Request for Additional Information No. 363, Supplement 6

U.S. EPR Standard Design Certification

SRP Section: 06.02.02 - Containment Heat Removal Systems

Question 06.02.02-43:

Figure 06.02.02-43-1—Strainer Profile Depicting Modeled Portion

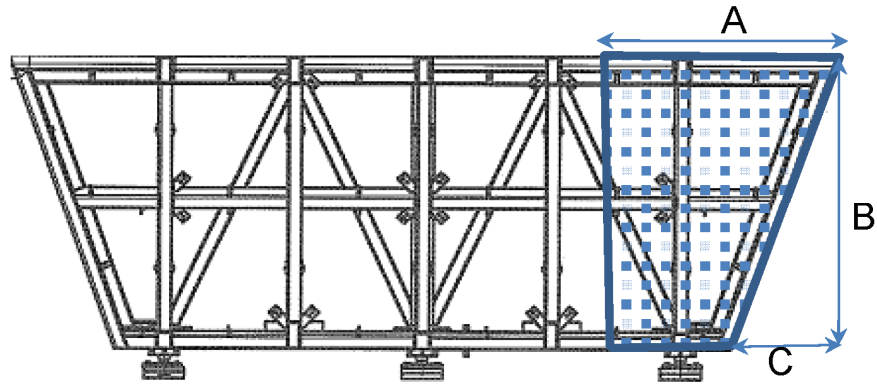
7. What is the basis for placing the RB bottom at the same elevation as the strainer bottom and how is this prototypical or conservative?
8. Describe the RB scaling approach. Explain how the tested RB surface area and tested RB volume are prototypical or conservative when compared to the plant.

Items in the U.S. EPR test apparatus that require scaling are the strainer, RB, flow, and design basis debris source term. The U.S. EPR strainer is shaped like an upside down trapezoidal prism (see Figure 06.02.02-43-1). Modeling one side (see 06.02.02-43, Face B) and a portion of the top (see Figure 06.02.02-43-1, Side A) of the strainer conservatively allows the test strainer to be aligned perpendicular to the flow, which maximizes the ability for debris to form a bed on the strainer. The slope angle of the slanted face of the test facility strainer is identical to the strainer designed for plant operation. A 0.75 foot portion on the bottom of the strainer is comprised of a skirt and support feet. This bottom portion has only limited active screen area and is not credited as strainer screen area in the scaling process. The skirt is not replicated in the test facility strainer.

The strainer width (not depicted in Figure 06.02.02-43-1) is determined by the physical size of the onsite test facility flume (5 feet width). The screened area of the modeled strainer in the test facility was determined by calculating the surface area using the test strainer's slanted screen height (7.5 feet), length (6.62 feet), and width (5 feet). Dividing the test flume strainer surface by the actual minimum strainer surface area for the U.S. EPR design yields a scale factor of 9.37 percent. Scaling the strainer as a single face perpendicular to the flow is conservative to the plant design and will provide a maximum head loss with respect to the U.S. EPR strainer.

Figure 06.02.02-43-2—Over-head View of Strainer Support and Sump Cover

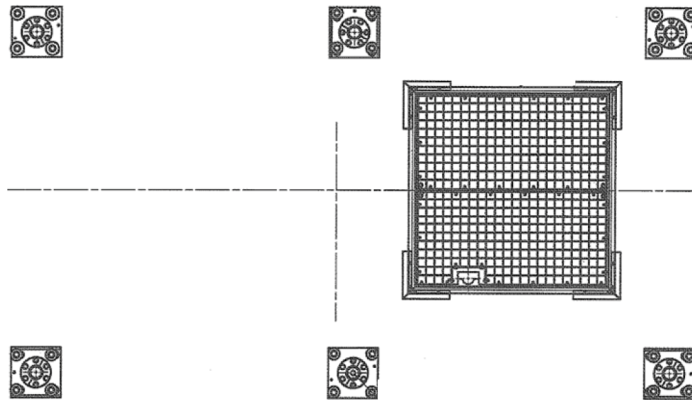
1. Describe the scaling methodology and explain how it ensures prototypical or bounding test data.
 - a. What similarities between test and plant conditions are preserved?

Figure 06.02.02-43-2 shows the layout of the strainer supports with respect to the sump cover (intake path for flow to the safety injection pump) for a strainer in the IRWST. To conservatively represent the flow within the strainer, the test facility represents the strainer face with the minimum clearance from the sump cover to the face of the strainer. Figure 06.02.02-43-1, Dimension A is determined by matching the distance from the strainer face directly to the leading edge of the sump cover. The sump cover size is scaled by flow area to the flow rate of the test flume.
